March 27, 2009  
 Subject: **T2 R8**  
 Federal Project No. BR-1562(700)S  
 State Pin No.015627.00  
**Amendment No. 1**

Make the following changes to the Bid Documents:

ESTIMATED QUANTITIES			
ITEM NO.	DESCRIPTION	QUANTITY	UNIT
202.12	REM EXIST STRUCTURAL CONCRETE	465	CY
202.13	REM EXIST RAILINGS - RET. BY DEPARTMENT	922	LF

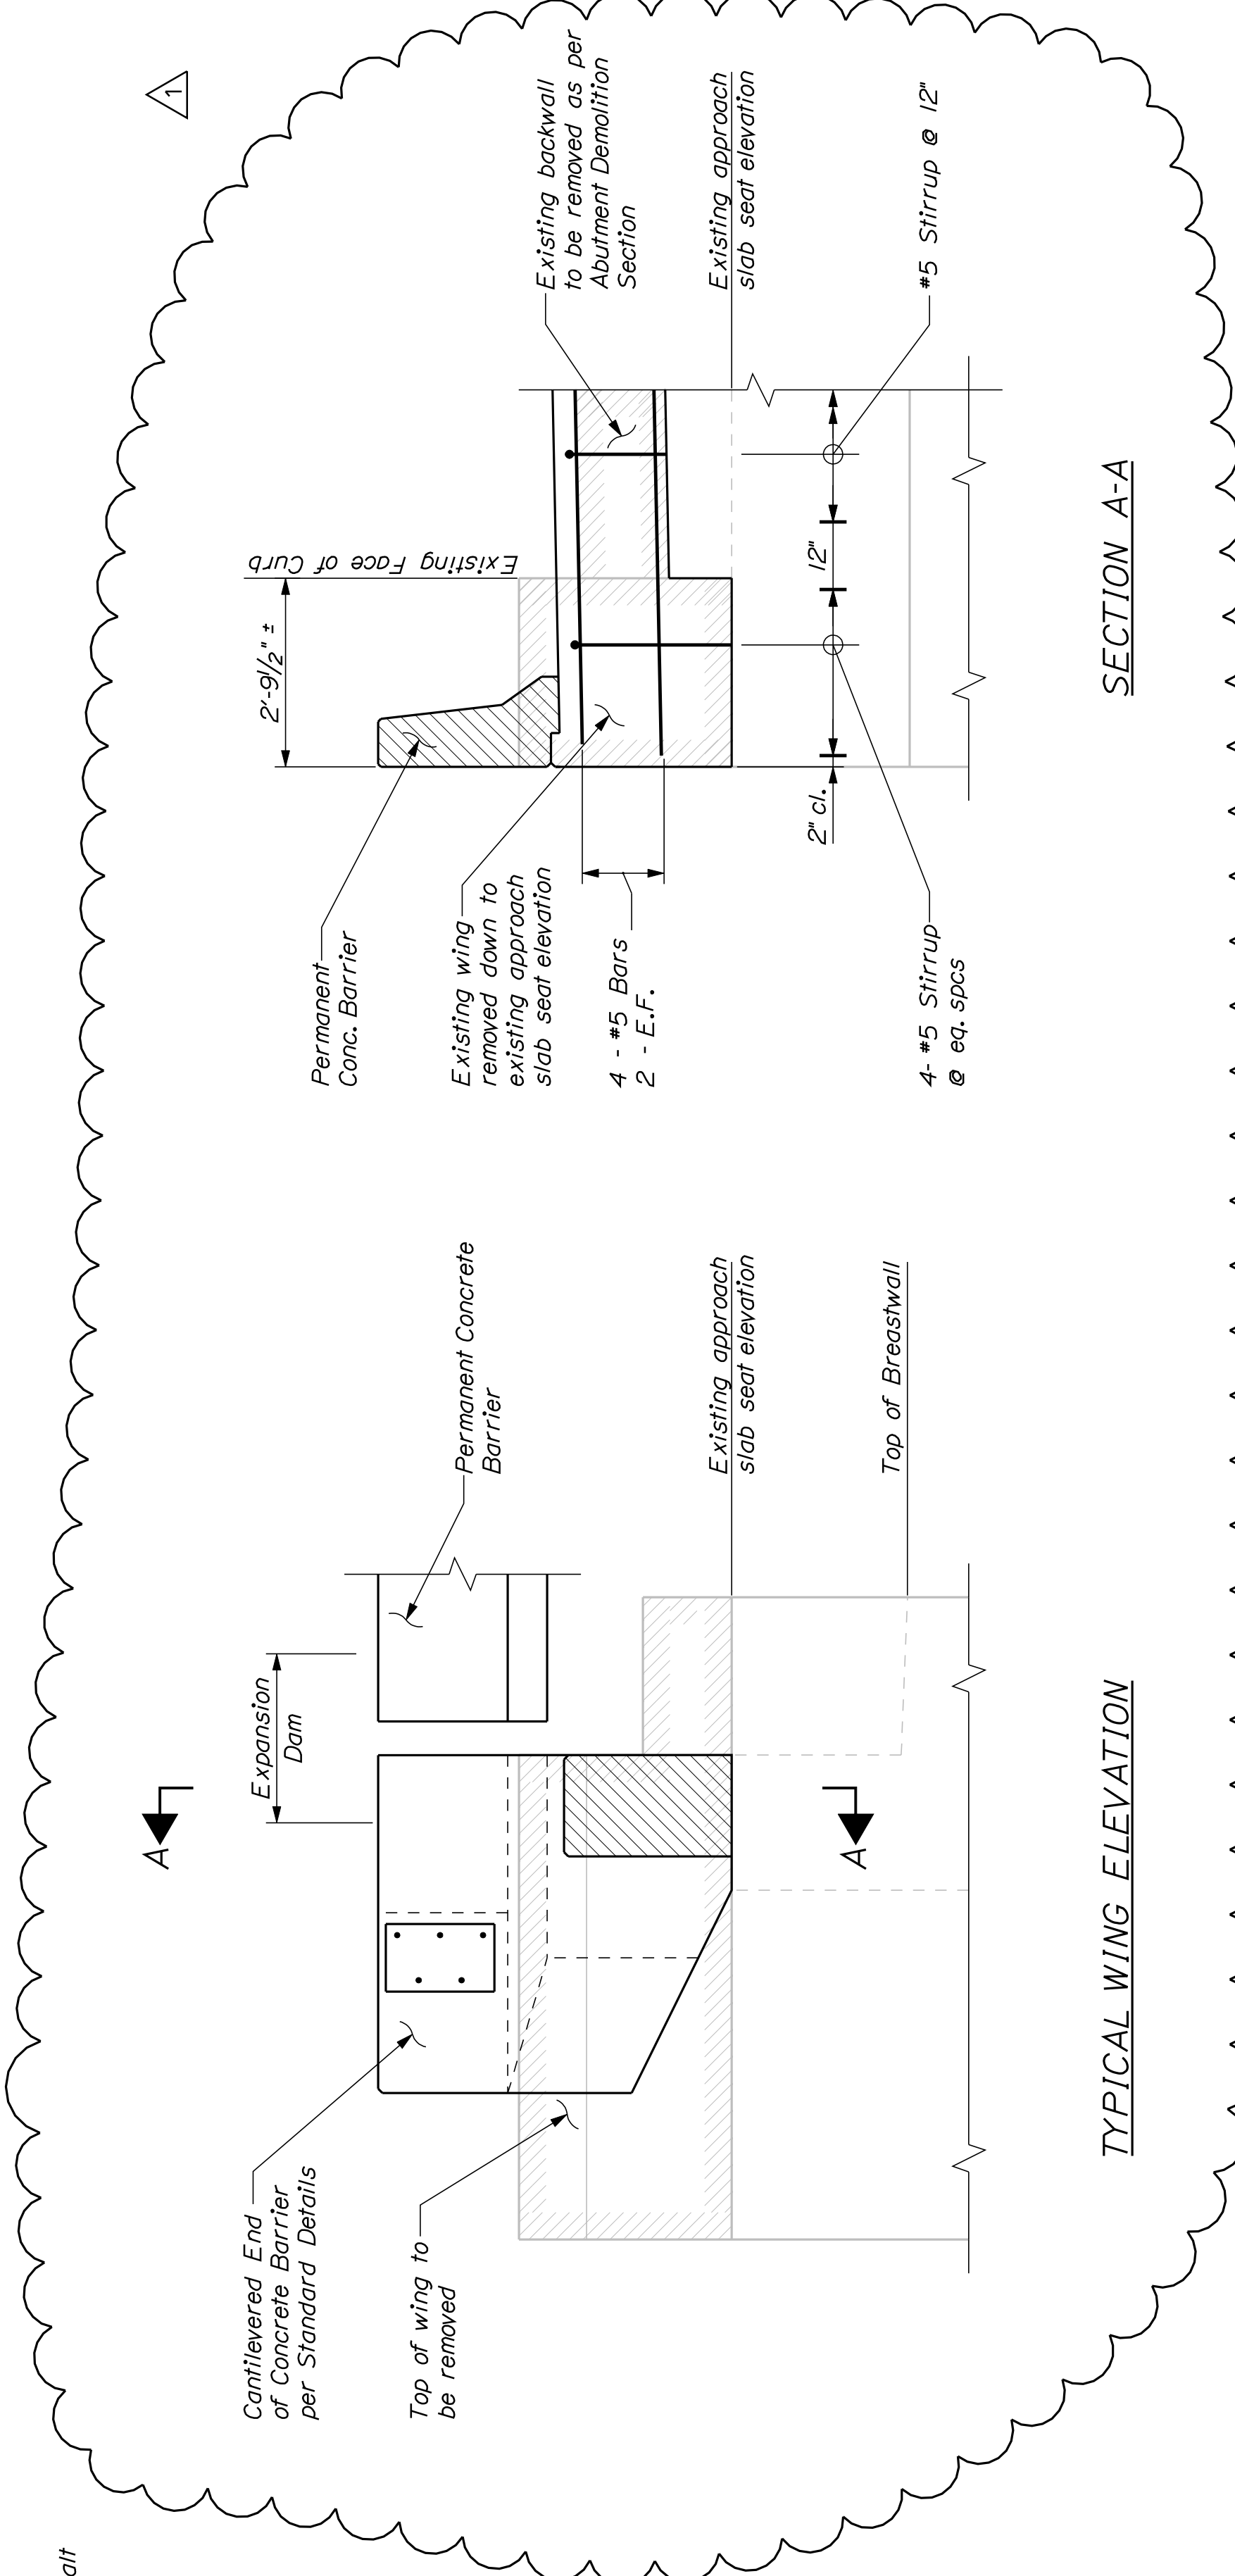
In the Amended Plans, Plan Sheet 2 of 11, "ESTIMATED QUANTITIES", **DELETE** the following items:

<b><u>506.18</u></b>	<b><u>CONTAINMENT AND POLLUTION CONTROL</u></b>	<b><u>1</u></b>	<b><u>LS</u></b>
<b><u>506.191</u></b>	<b><u>DISPOSAL OF SPECIAL WASTE OR HAZARDOUS WASTE</u></b>		
	<b><u>MATERIAL</u></b>	<b><u>1</u></b>	<b><u>LS</u></b>

**Question:** What is the connection detail for the temporary barrier on both the existing and new deck?

**Response:** Please see the new Plan Sheet 2 of 11, replaced in this amendment.

- The temporary concrete barrier positioned on the existing and new bridge decks shall be positively attached to the concrete deck. The method of attachment shall be designed and stamped by a professional engineer registered in the State of Maine and approved by the Resident. This work shall not be paid for directly. Payment shall be considered incidental to related contract items.

**FRAMING PLAN**  
Rotate 180° about  $\bar{\bar{C}}$  Pier No. 3  
For Span Nos. 5 & 6

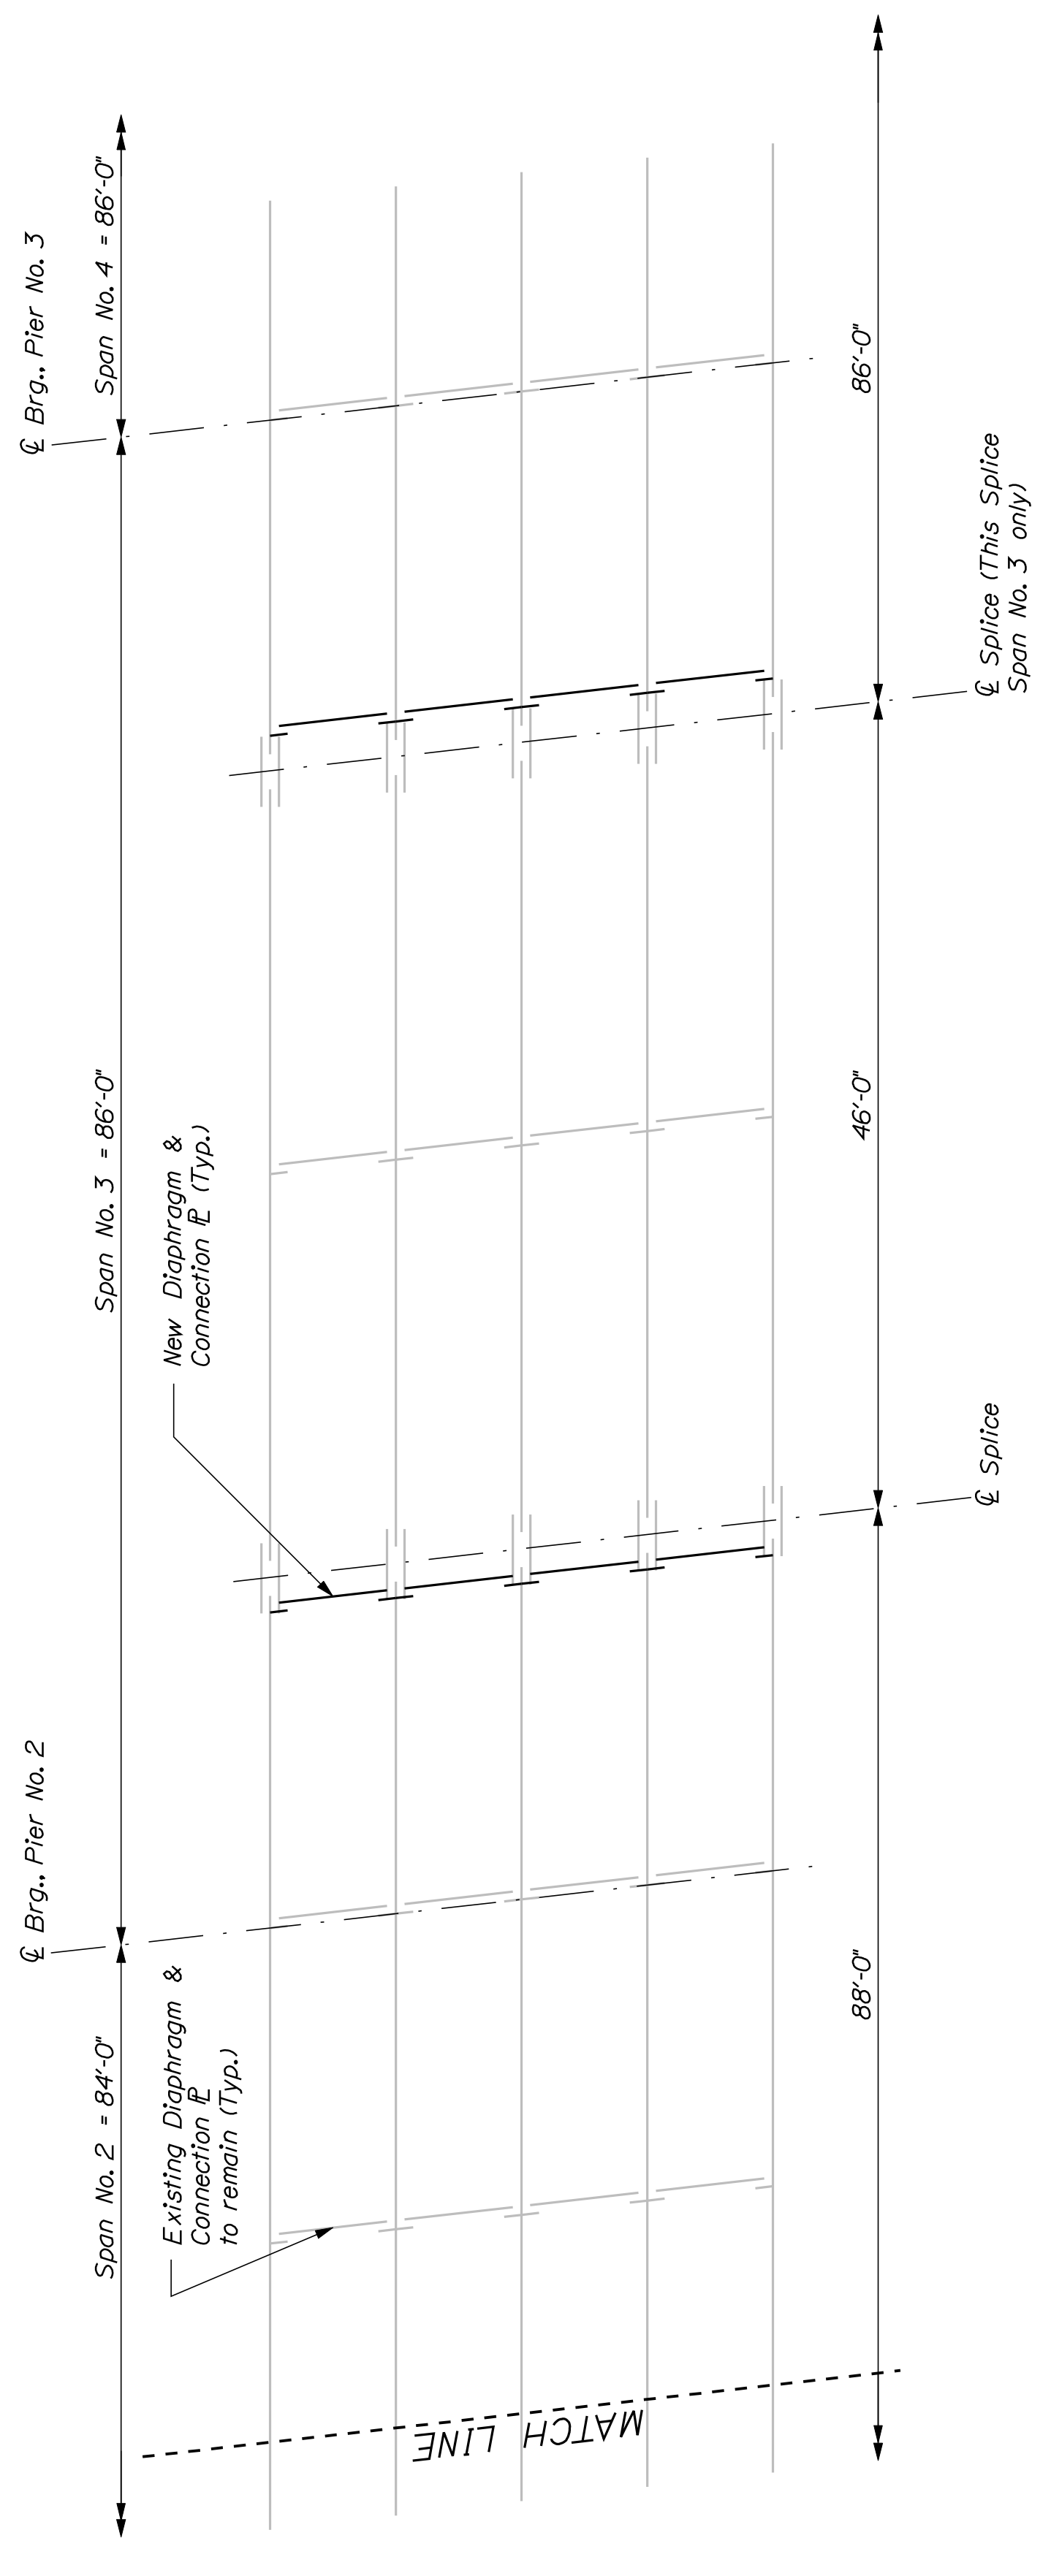
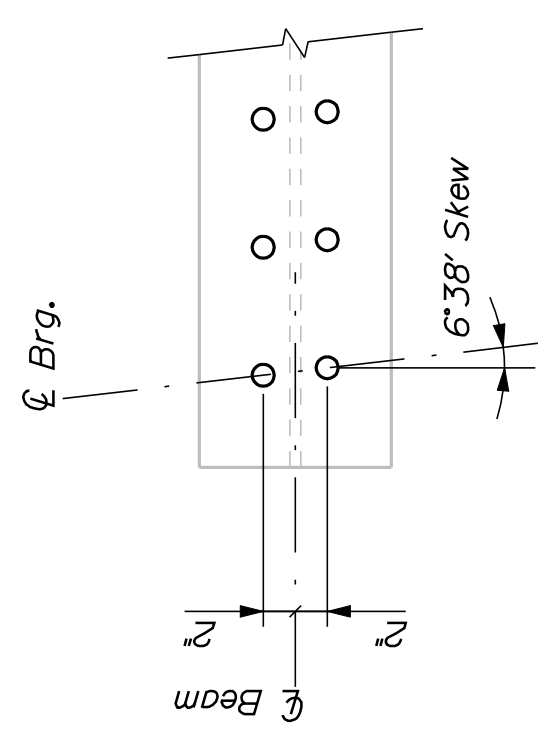
**Question:** Reference Sheet 7, Top Flange Repair, it is unclear how many top flange repairs are required. Due to the small quantity of steel and the labor intensive repair of the top flange detail, can the diaphragm replacement and the top flange repair be two bid items?

**Question:** Without an estimated quantity of top flange repairs for bid items, 506.18 and 506.191, there is no basis for the lump sum pricing. Can estimated quantities be provided?

**Response:** Please see the new Plan Sheet 6 of 11, replaced in this amendment.

**Response:** Please see the new Plan Sheet 6 of 11, replaced in this amendment.
